Field Change Notice

Number 1
 Date APRIL 15, 1982
 Page 1 of 4

Models Affected: ADVANTAGE Class of Change: MANDATORY
 Assembly(s) Affected: ADV BASE ASSY Field Action: INSTALL ON NEXT CALL
 Factory Implementation: 5-1-82 Est. Install. Time: 0.5 Hrs.

ADVANTAGE GROUNDING RETROFIT INSTRUCTIONS

FIGURE 2

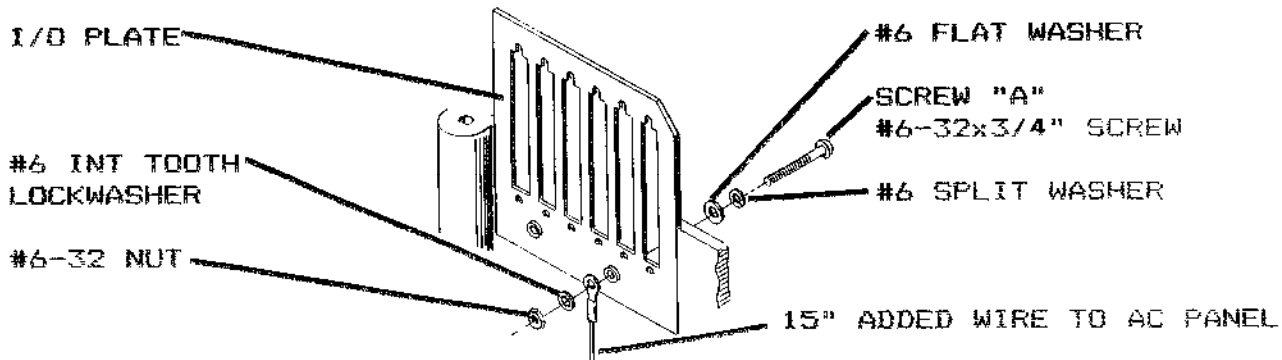
4. Attach one end of each of the two wires supplied in the kit to the screw removed in step 3 along with the two wires already attached to the screw and replace the screw on the AC power panel.
5. Using Figure 2 as a reference, remove screw A on the I/O mounting panel. Discard this screw.

6. Using the hardware supplied in the kit, install the loose end of the 15" wire to the I/O mounting plate as shown in Figure 2.
7. Using Figure 3 as a reference, remove screw A on the disk drive mounting bracket.

FIGURE 3

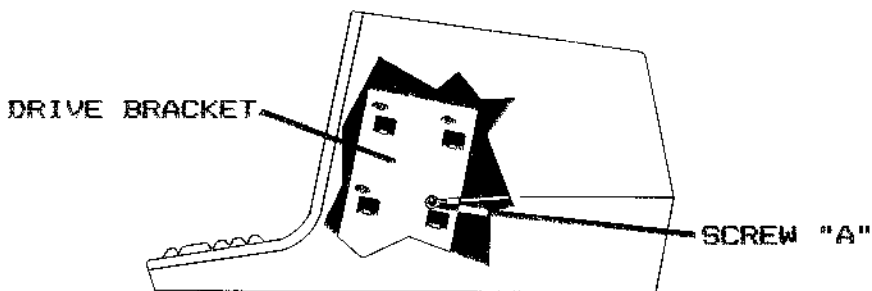
8. Connect the loose end of the 7" wire to the drive mounting bracket using the screw removed in step 7.
9. Using a DVM, check to make certain that there is zero ohms between the I/O mounting panel, the disk drive bracket and the AC power panel.
10. Replace the Advantage top cover as described in Section 6.5.2 of the Advantage Technical Manual.

FIGURE 1

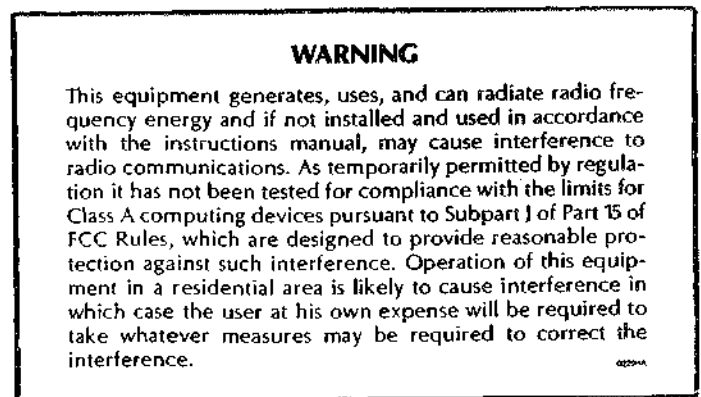
FCC stickers (see Figure 1) must be affixed to all unsold ADVANTAGE computer systems and ADVANTAGE USER MANUALS in order to comply with Federal Communications Commission regulations.

Application of a self adhesive FCC sticker (North Star Part Number 02292A) to rear of all ADVANTAGE computers currently in inventory. Application of a self adhesive FCC sticker (North Star Part Number 02294A) to the inside surface of the rear cover of all ADVANTAGE USER MANUALS currently in inventory.

FIGURE 2

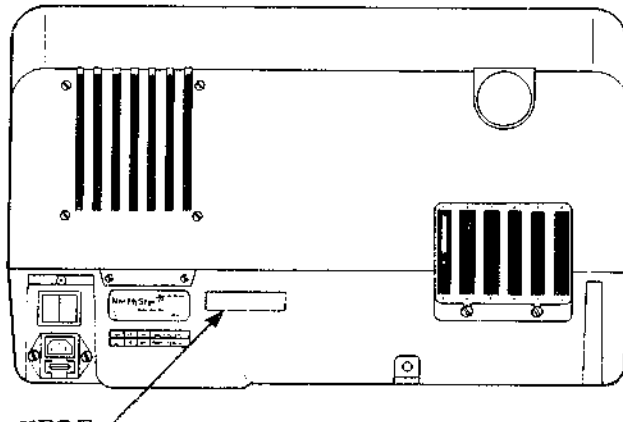
Apply self adhesive FCC sticker (North Star Part Number 02292A) to the rear of all ADVANTAGE computer systems currently in inventory as indicated in Figure 2.

FIGURE 2

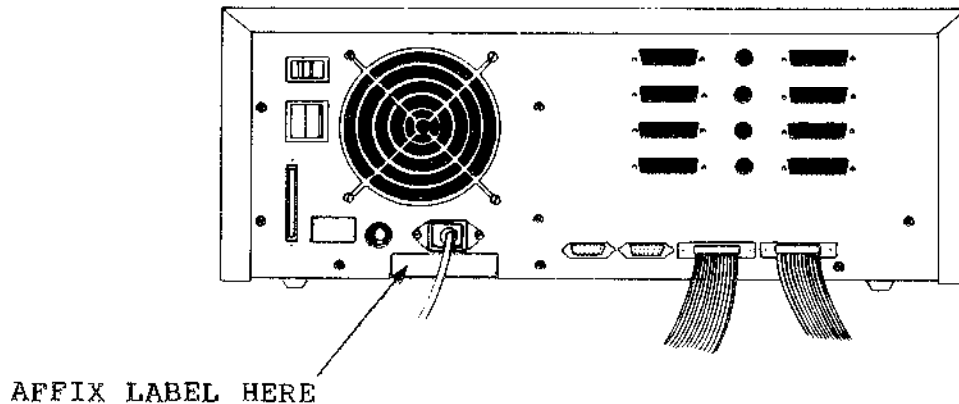
Apply self adhesive FCC sticker (North Star Part Number 02292A) to the rear of all HORIZON computer systems currently in inventory as indicated in Figure 2.

FIGURE 2

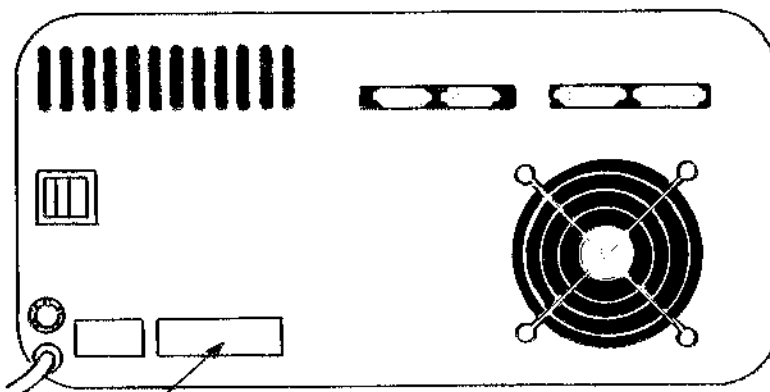
Apply self adhesive FCC sticker (North Star Part Number 02292A) to the rear of all HD-18 hard disk systems currently in inventory as indicated in Figure 2.

FIGURE 2

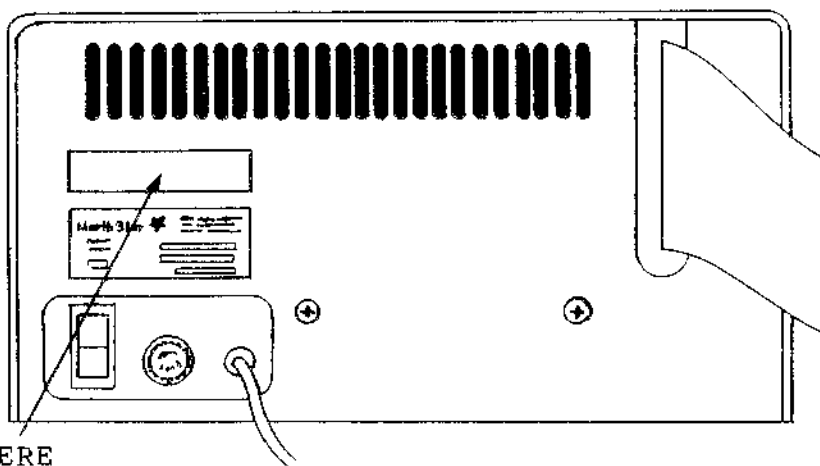
Apply self adhesive FCC sticker (North Star Part Number 02292A) to the rear of all TAPE BACK-UP SYSTEMS currently in inventory as indicated in Figure 2.

FIGURE 1

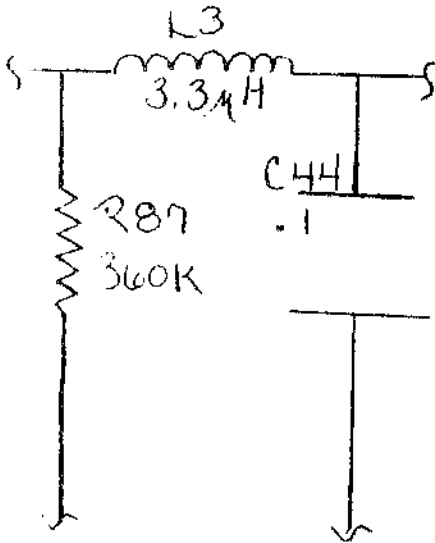
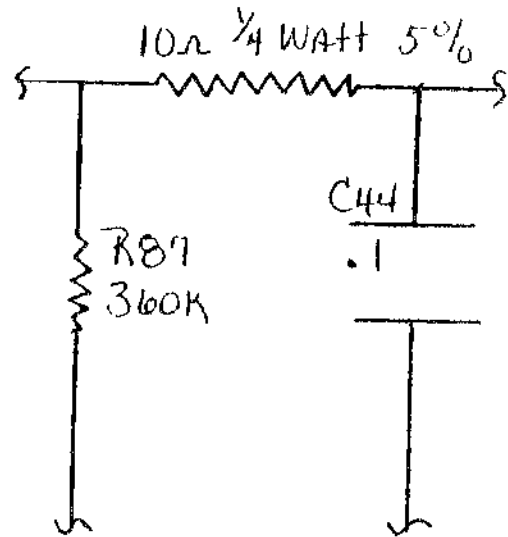
This modification to the ADVANTAGE main PCB will eliminate the half dot shift in the linearity of the lower 2/3 of the ADVANTAGE video screen.

The modification is accomplished by removing L3 (3.3 micro henry coil) located at IC 1A on the main PCB of the ADVANTAGE and replacing it with a 10 ohm 1/4 watt resistor designated R108.

4. Using Figure 1 as a reference, desolder L3 (3.3 micro henry inductor) at location IC 1A on the main PC Board.
5. Remove the excess solder from solder pads and holes.

6. Install resistor (North Star P/N 61053) 10 ohm, 1/4 watt, 5% in place of L3.
7. Replace ADVANTAGE top cover as outlined in Section 7.3.1 of the ADVANTAGE Technical Manual.

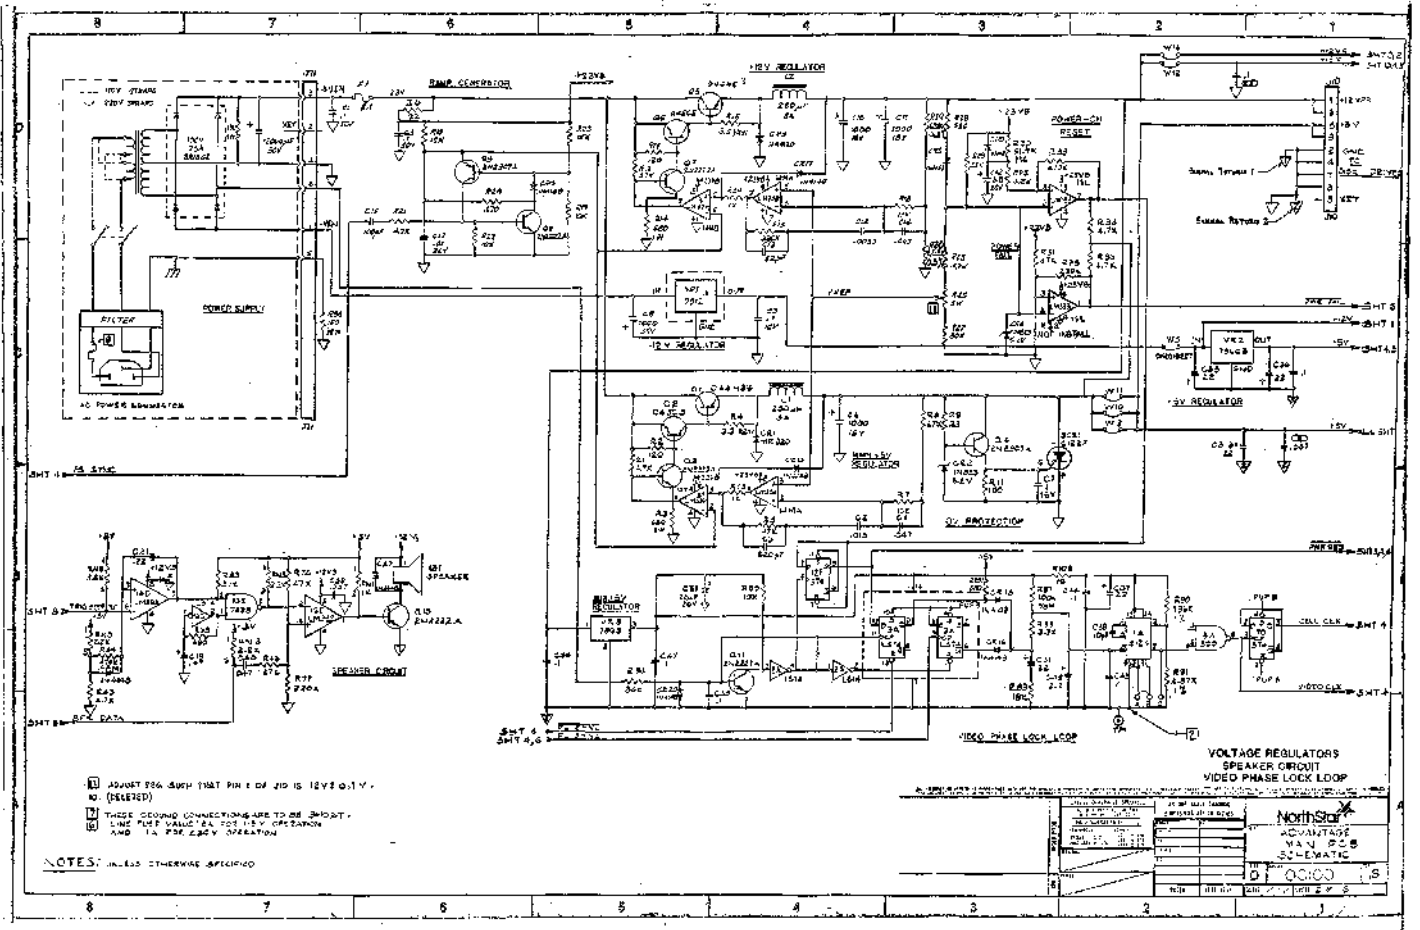
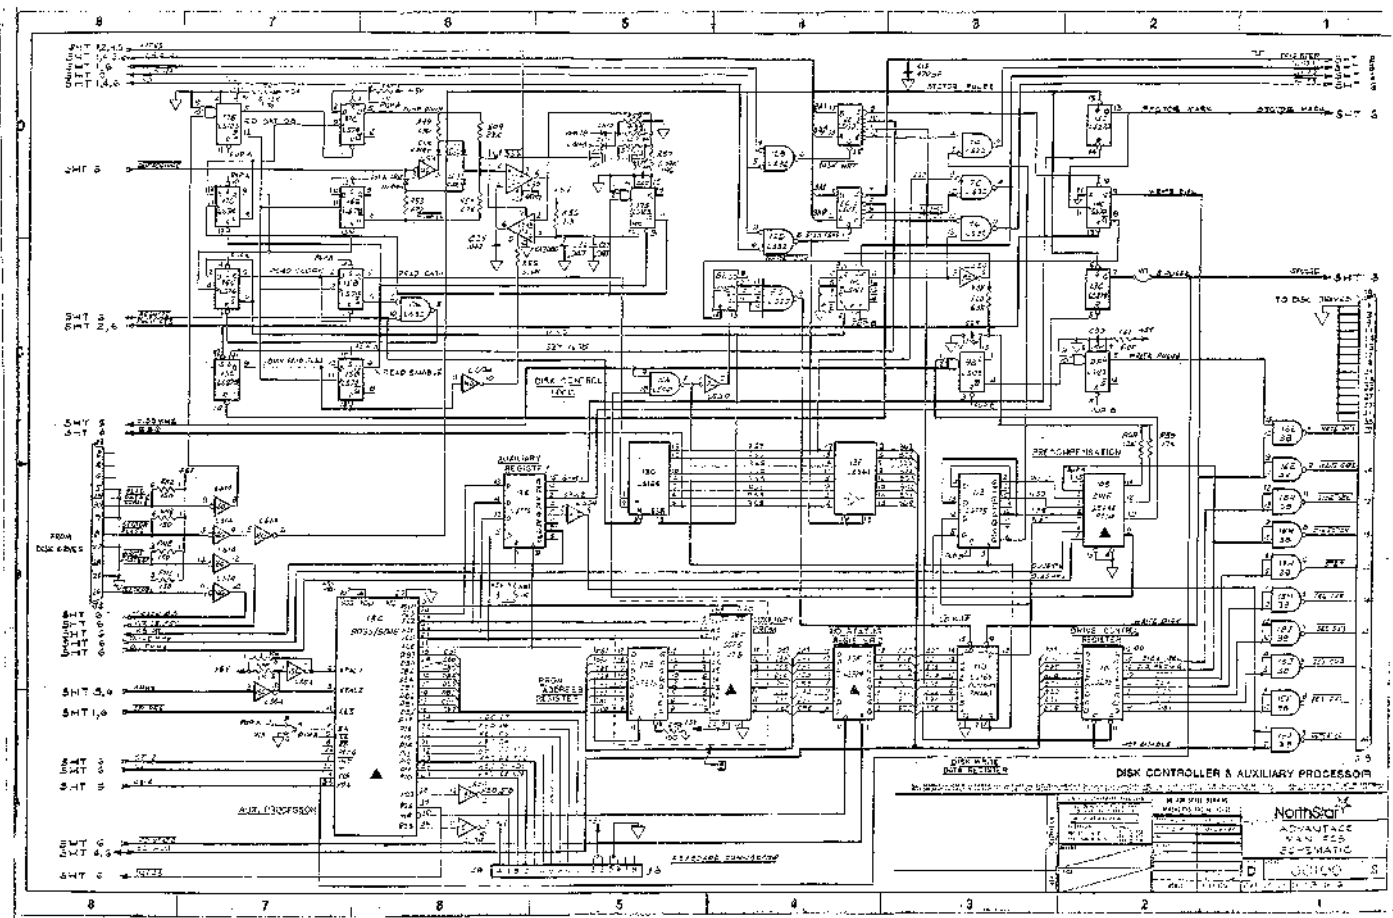
Schematic, ADVANTAGE Main PCB (North Star Drawing #00100)
from Revision P to Revision S (copy attached)
